CITY OF ALBUQUERQUE

RE: **Lot 10 Block 11, Volcano Cliffs, Unit 22, SAD 228
6512 Petirrojo NW
Grading and Drainage Plan
Engineers Stamp Date 2/18/19 (D10D003H24)**

PROJECT TITLE	MADRID RESIDENCE
SHEET TITLE	GRADING AND DRAINAGE PLAN

GRADING AND DRAINAGE PLAN

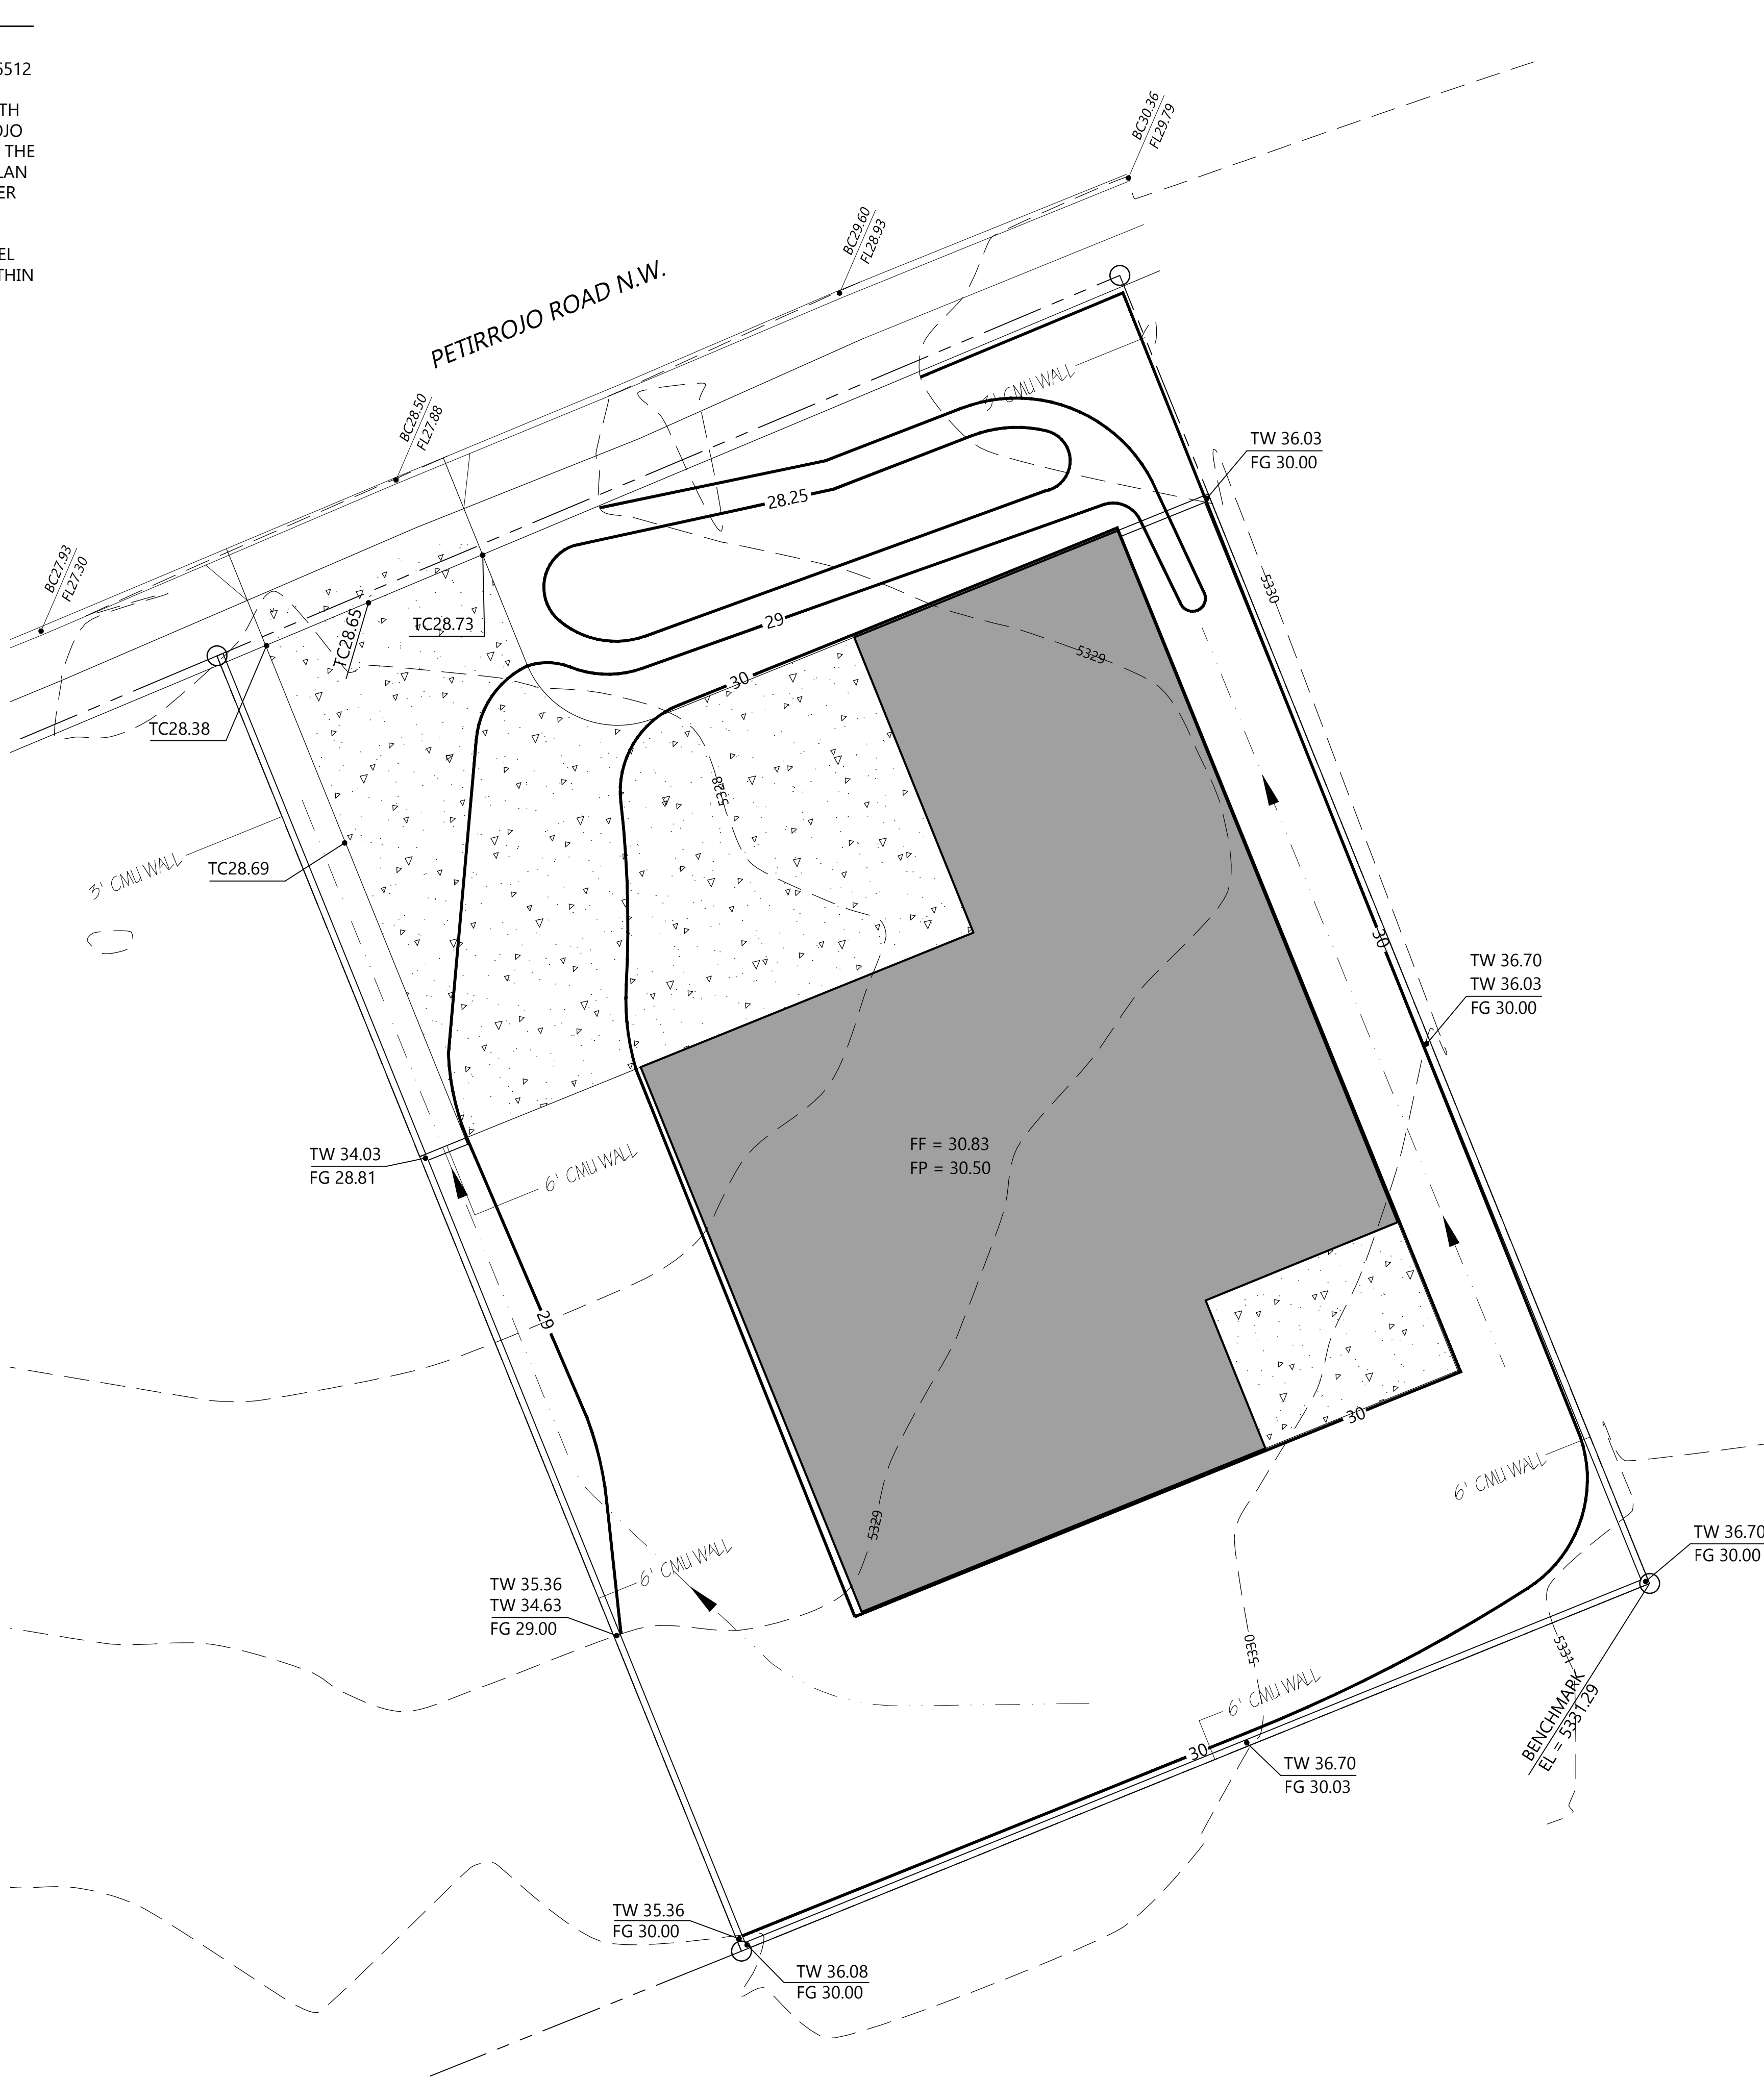
Prior to Building permit approval a Pad Certification will be required, provided by the Engineer or a registered Land Surveyor. Provide this note on the plan in the notes section.

Reiterate to the Owner/Contractor that a separate permit for a garden/retaining wall must be obtained with the approved G&D plan and Pad Certification. Provide this statement on the plan in the notes section. Also provide a note stating that openings in the block wall are required and the bottom of the openings should be 3" above grade, provide calculations for openings.
